# Access Compliance Report

## Public Rights-of-Way

Intersection ID: 49003	Main Street: STEELE_CREEK_RD	Cross Street: STEELECROFT_PY	Location: SE
ADA ID: 6FD9E8E168BE	Ramp Type: PerpDiag	Initial Pass/Fail: Fail	Overall Compliance: No
		Severity Score: 12.5

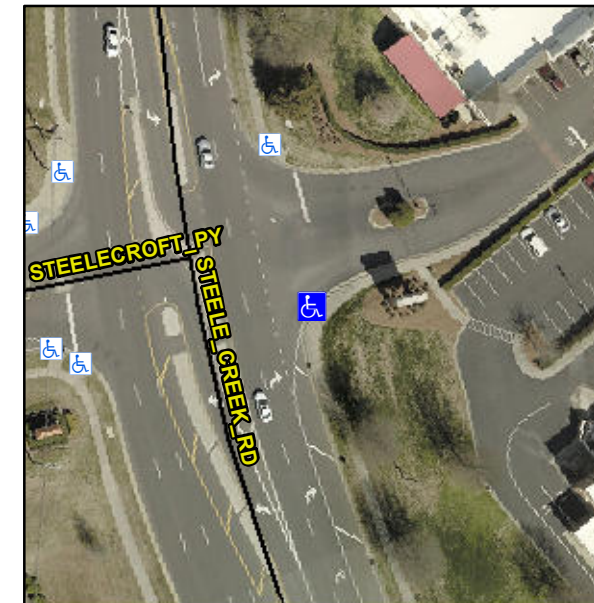
**R304.2.2**

Compliance	Description	Data	Compliance	Description	Data
N/A	Ramp Length (in)	96.0	No	Ramp Slope (%)	9.3
Yes	Ramp Width (in)	48.0	Yes	Ramp XSlope (%)	0.8
N/A	Flare Type LT	N/A	N/A	Flare Type RT	N/A
N/A	Flare Slope LT (%)	N/A	N/A	Flare Slope RT (%)	N/A
N/A	Flare Traversable LT?	N/A	N/A	Flare Traversable RT?	N/A
N/A	Landing Length (in)	N/A	N/A	DWS Provided?	N/A
N/A	Landing Width (in)	N/A	N/A	DWS Contrast?	N/A
N/A	Landing Slope (%)	N/A	N/A	DWS Length (in)	N/A
N/A	Landing X Slope (%)	N/A	N/A	DWS Full Width?	N/A
N/A	Landing Curb? (Y/N)	N/A	N/A	DWS Offset (in)	N/A
N/A	Shared Landing?	N/A			
N/A	Gutter Ponding?	N/A	N/A	Gutter Slope (%)	N/A
N/A	Gutter Lip Ht (in)	N/A	N/A	Gutter X Slope (%)	N/A
N/A	Painted X Walk1?	No	N/A	Painted X Walk2?	No
	X Walk 1 Direction	To N		X Walk 2 Direction	To W
N/A	X Walk 1 Width (in)	N/A	N/A	X Walk 2 Width (in)	N/A
	X Walk 1 Slope (%)	1.6		X Walk 2 Slope (%)	1.5
	X Walk 1 X Slope (%)	0.0		X Walk 2 X Slope (%)	0.6

**Remove & Replace Curb Ramp With Two New Directional Ramps or Equivalent.**
